PP No. PPSSTH-119 DA0606/2021

Formerly Lot 9009 DP1254656 The Promontory Drive, Shell Cove (Precinct C2)

Attachment 10 – DCP Compliance Table

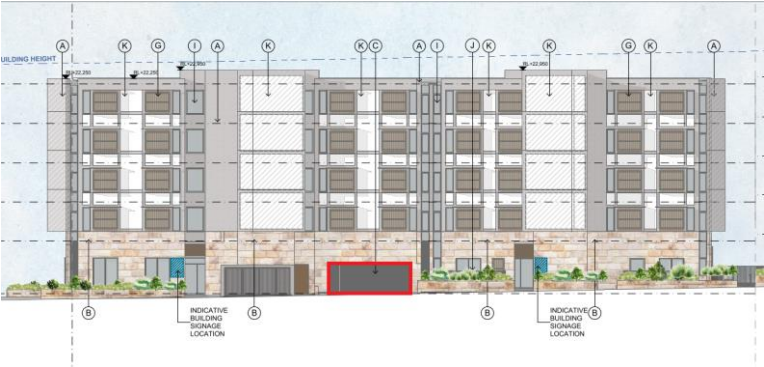
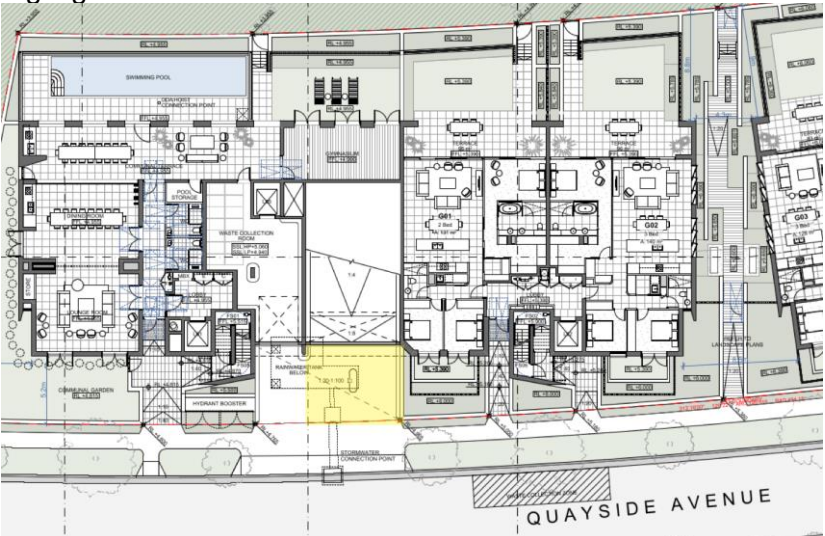
13.2 Access and Design	The car parking dimensions are compliant with the DCP requirements.	Car space dimensions and driveway width comply. Aisle widths are considered acceptable.

<p>Minimum dimensions required for a single car space are: length x width</p> <ul style="list-style-type: none"> a. 5.5m x 2.6m - open car space b. 5.5m x 2.9m - car space abuts one wall c. 5.5 x 3.1m - car space enclosed both sides by building or walls d. 6.1m x 2.5m - parallel parking 	<p>All aisles are a minimum 5.8m wide and comply with Australian Standards.</p>	
<p>Basement Car Parking 13.2.20 Vehicular entrances must be integrated into the streetscape. Garage doors, shutters and grills must not be visually obtrusive and must blend in with the appearance of the buildings.</p>	<p>The proposed roller shutter will be recessed into the development with an approximate 6.3 metre setback from the western boundary of the development.</p> <p>The door will be set back from the western elevation of Building 1 and will not appear visually obtrusive from the street. The door will blend in with the appearance of the building as the grills screening the utilities infrastructure for the building will be similar same design and materials as the door.</p>	<p>Complies.</p>  <p>Figure 10.1 - basement car parking entrance</p> <p>Roller door outlined in red.</p>
